STATION SERVICES CHANGE ORDER 1577-2.1-05

DUKE POWER COMPANY

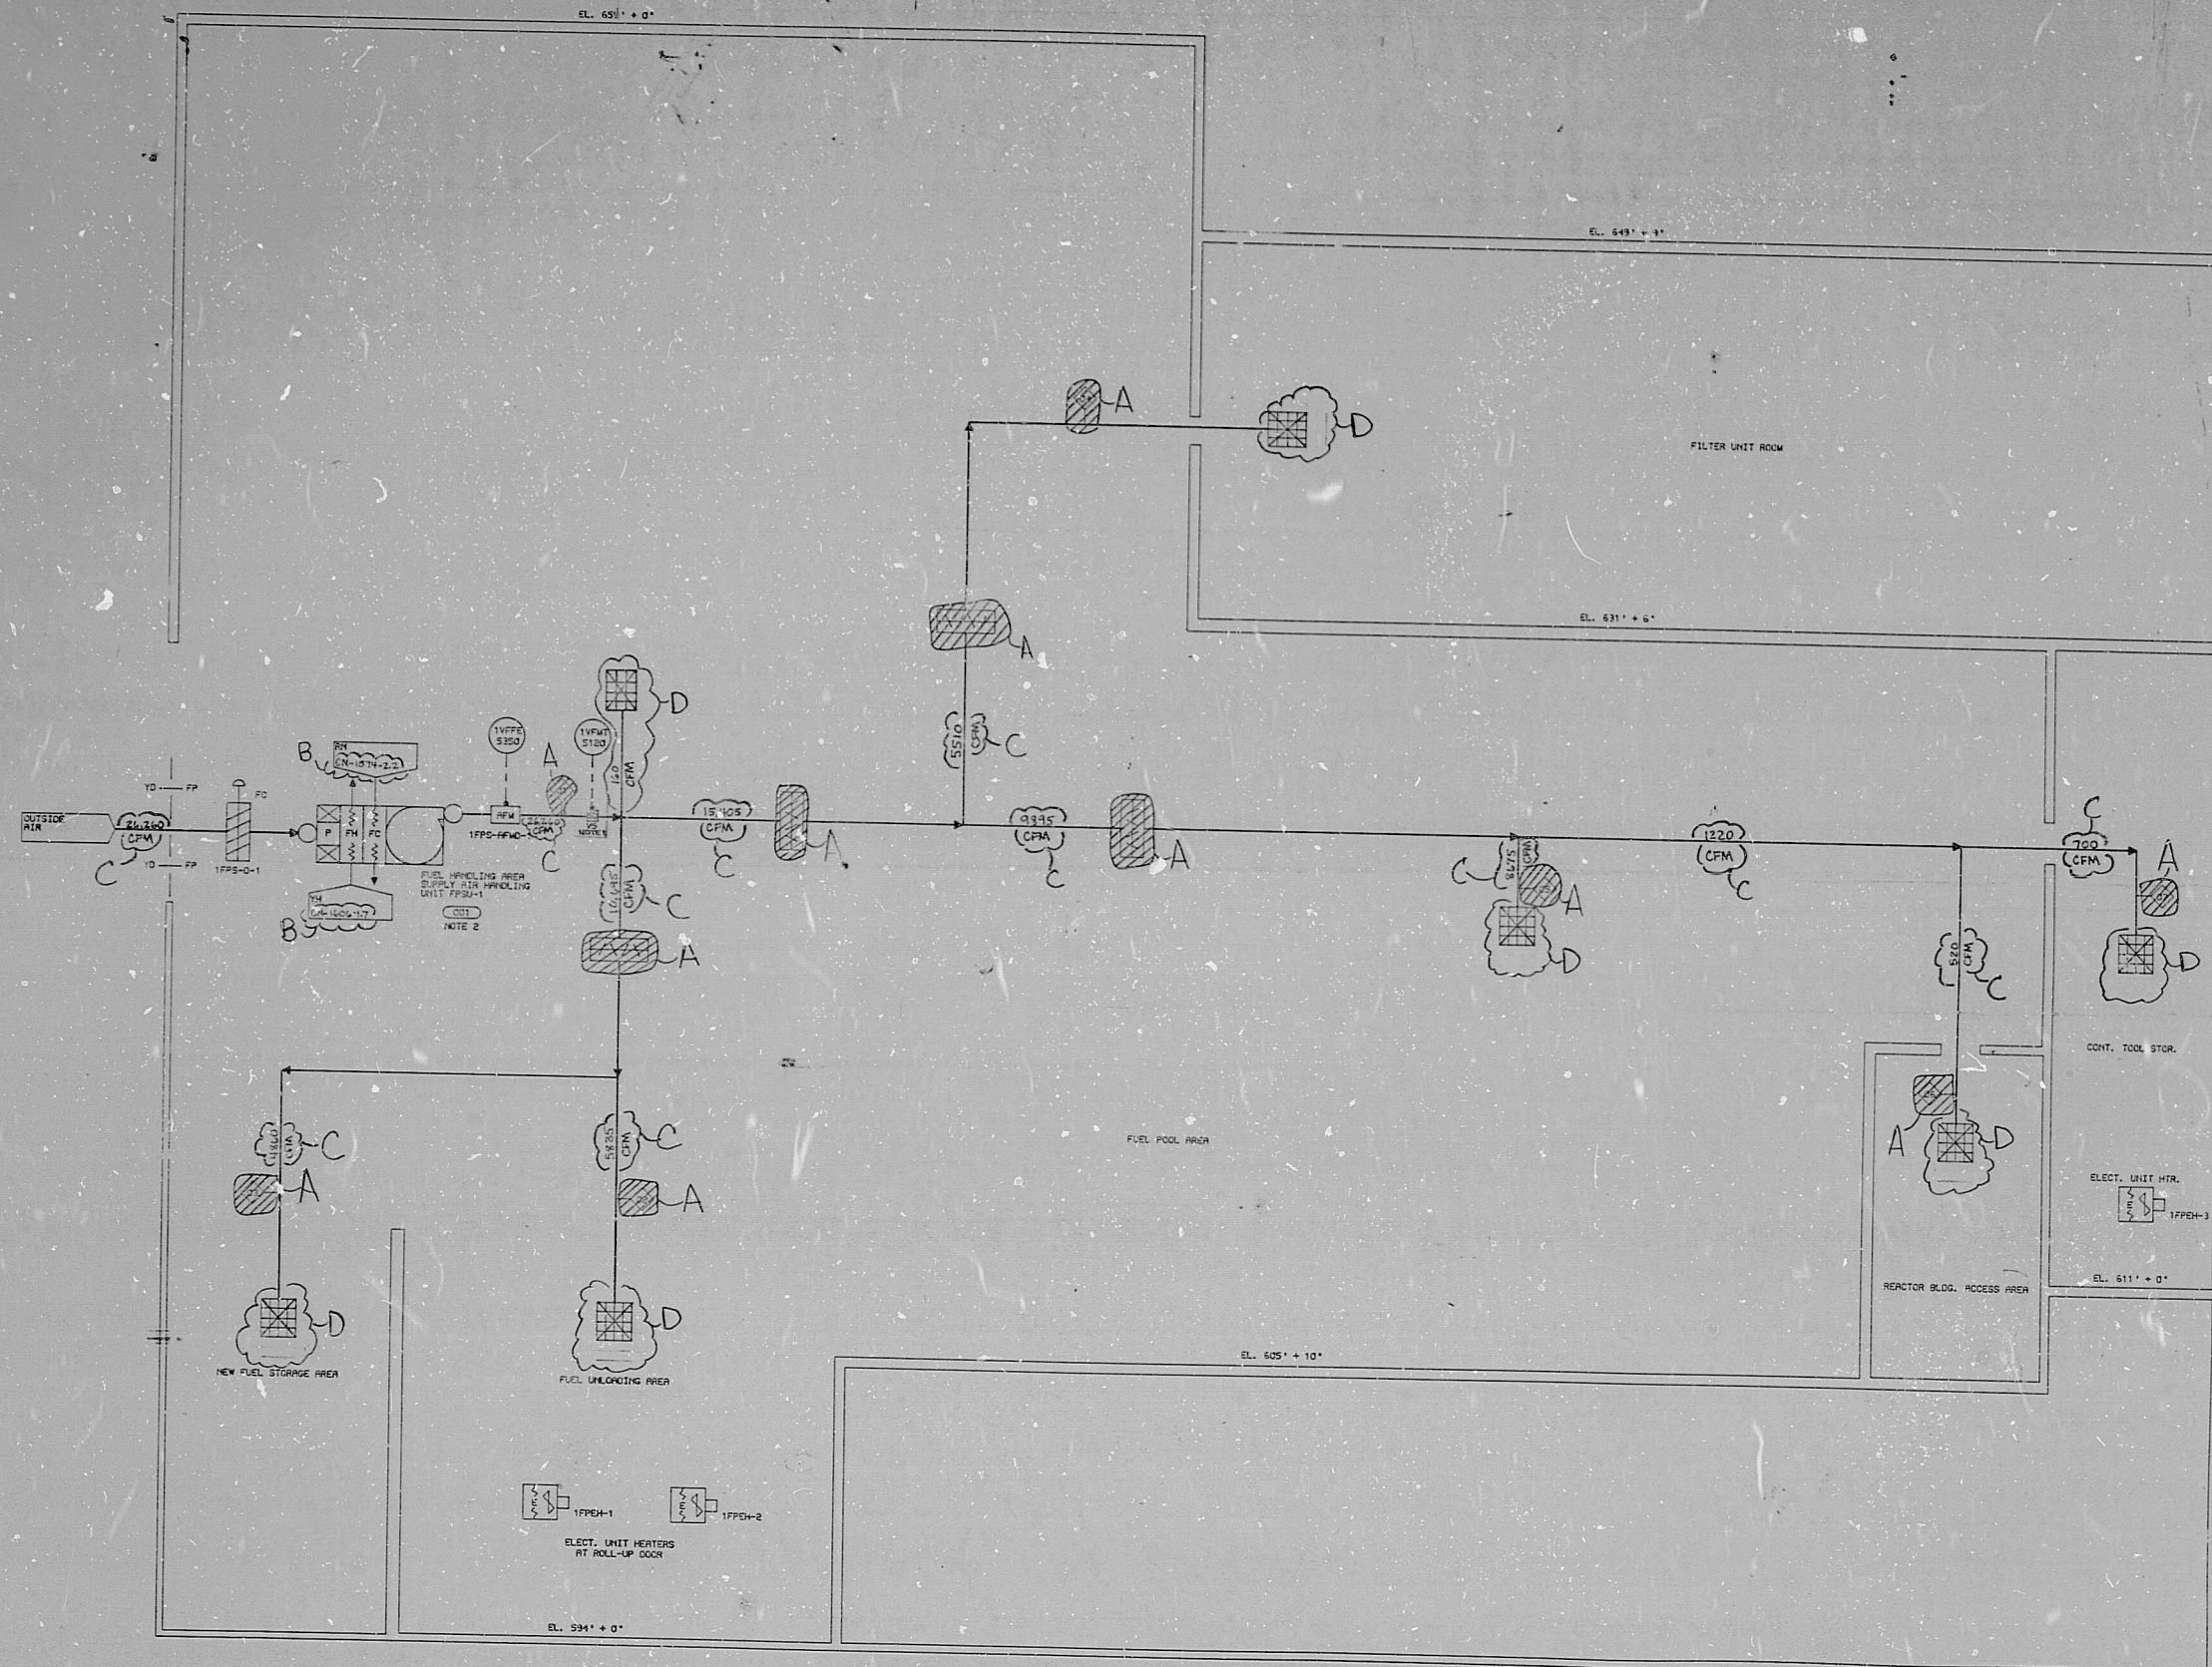
NO.	DESCRIPTION	DATE	BY	CHKD.
1	DELETE AREA A	11/1/77	...	...
2	DELETE AREA B	11/1/77	...	...
3	DELETE AREA C	11/1/77	...	...
4	DELETE AREA D	11/1/77	...	...
5	DELETE AREA E	11/1/77	...	...
6	DELETE AREA F	11/1/77	...	...
7	DELETE AREA G	11/1/77	...	...
8	DELETE AREA H	11/1/77	...	...
9	DELETE AREA I	11/1/77	...	...
10	DELETE AREA J	11/1/77	...	...
11	DELETE AREA K	11/1/77	...	...
12	DELETE AREA L	11/1/77	...	...
13	DELETE AREA M	11/1/77	...	...
14	DELETE AREA N	11/1/77	...	...
15	DELETE AREA O	11/1/77	...	...
16	DELETE AREA P	11/1/77	...	...
17	DELETE AREA Q	11/1/77	...	...
18	DELETE AREA R	11/1/77	...	...
19	DELETE AREA S	11/1/77	...	...
20	DELETE AREA T	11/1/77	...	...
21	DELETE AREA U	11/1/77	...	...
22	DELETE AREA V	11/1/77	...	...
23	DELETE AREA W	11/1/77	...	...
24	DELETE AREA X	11/1/77	...	...
25	DELETE AREA Y	11/1/77	...	...
26	DELETE AREA Z	11/1/77	...	...
